SUBJECT: RESOLUTION OF DEGRADED CEQ FAN ROOM WALL

SUBJECT: RESOLUTION OF DEGRADED CEQ FAN ROOM WALL

SUBJECT: DONALD C. COOK - SUMMARY OF JUNE 1, 2000, PUBLIC MEETING
REGARDING CONTAINMENT SUBCOMPARTMENT WALLS

NRC STAFF QUESTIONS CONCERNING OPERABILITY OF
SUBCOMPARTMENT WALLS - D. C. COOK UNIT 2

Description of the Issues: Open Pockets - Configuration of Unit 2 Ice Condenser Column Anchorage

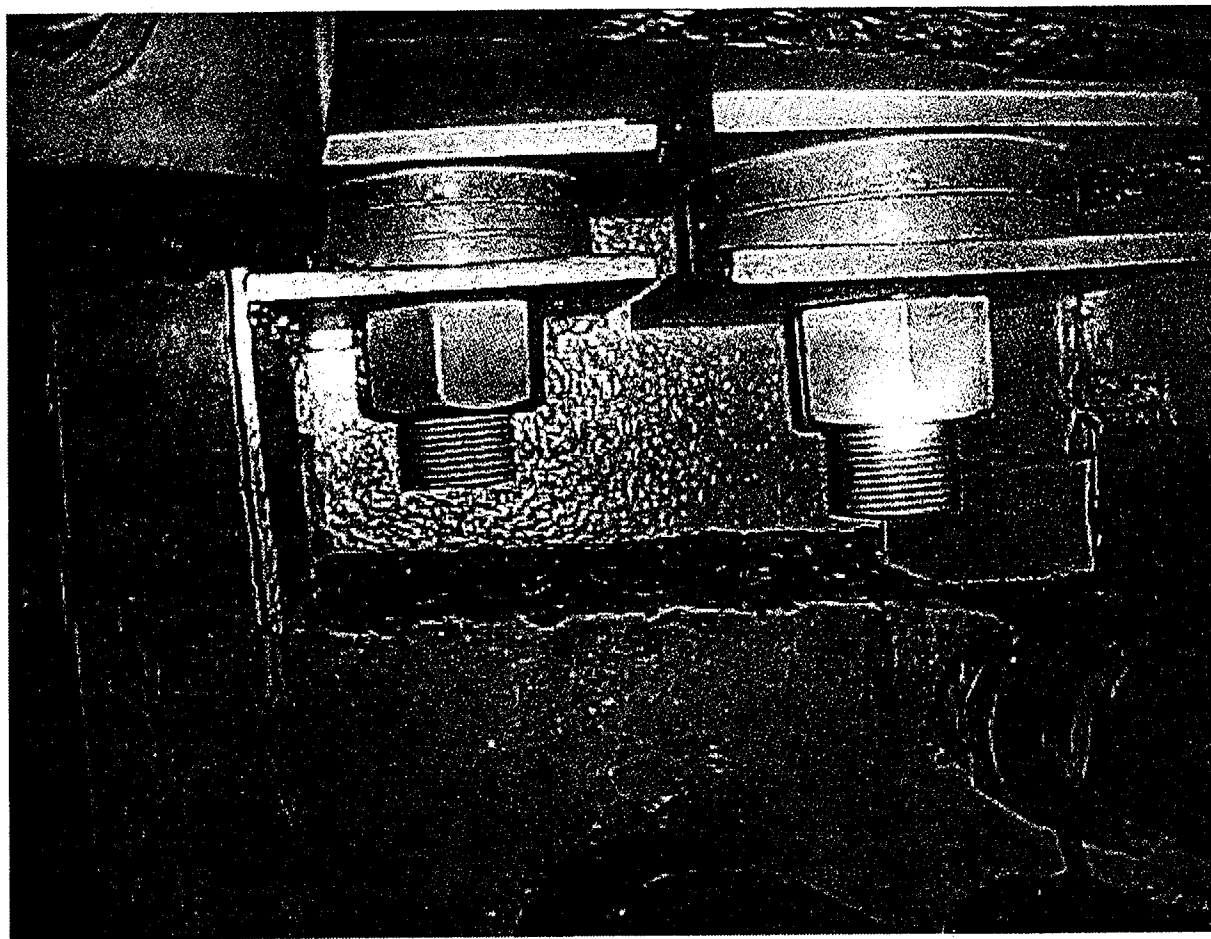
- **Pockets at Top of 126° Wall for Bolting**
- **Design Required Pockets to be Grouted**
- **Pockets Left Open From Original Construction**

Description of the Issues: Cut Rebar

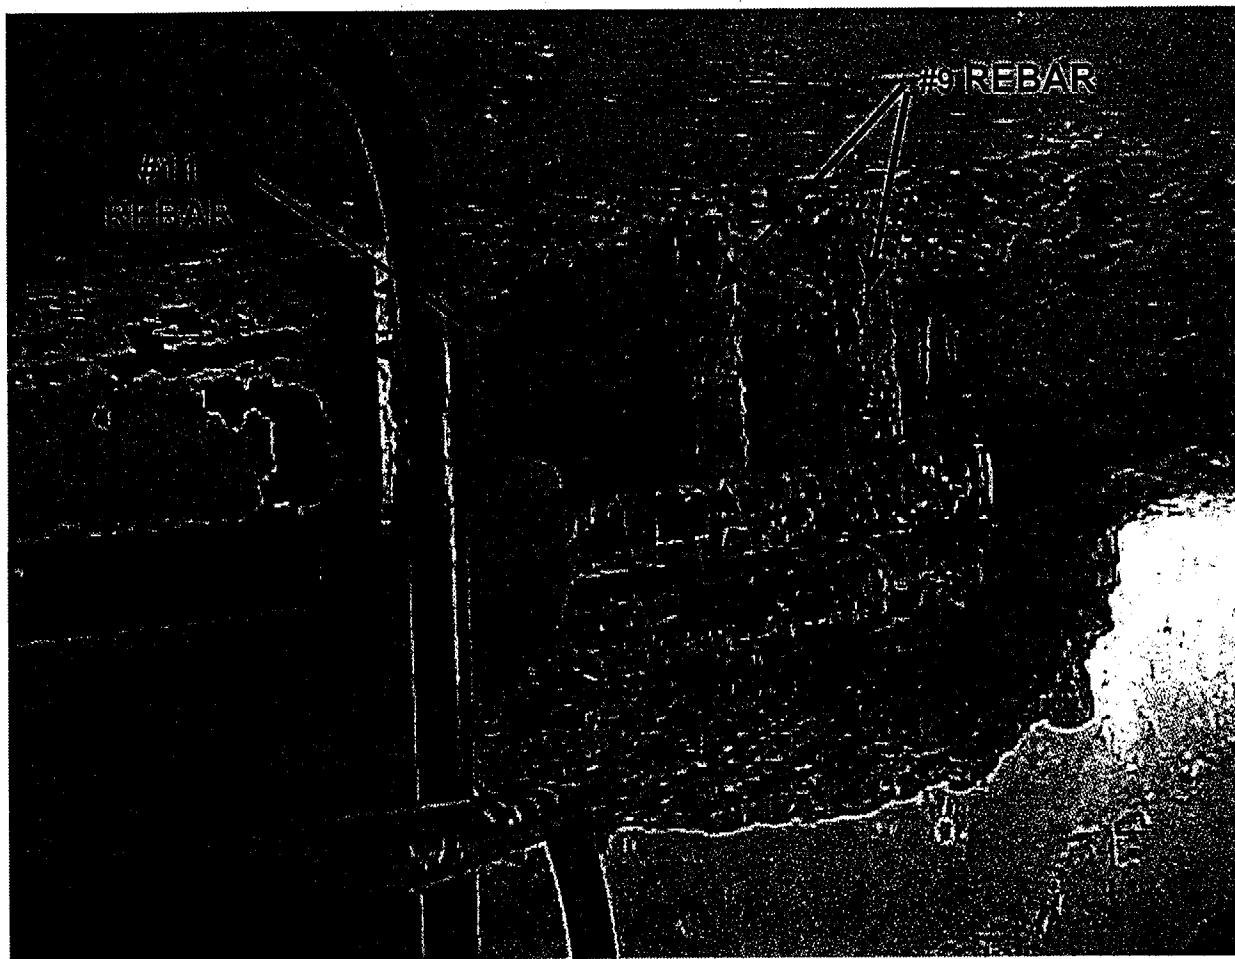
- **Vertical Rebar Cut at Top of 126° Wall**
- **Cuts Required for Installation of Ice Condenser Anchorage**
- **Excavation Determined Extent of Condition on 126° Wall**
- **Issue Limited to 126° Wall**

5. Justify the use of the 3 vertical bars in determining shear capacity at the top of wall 126.
6. Provide the long term plan for wall 126 with regard to its conformance with design basis requirements.
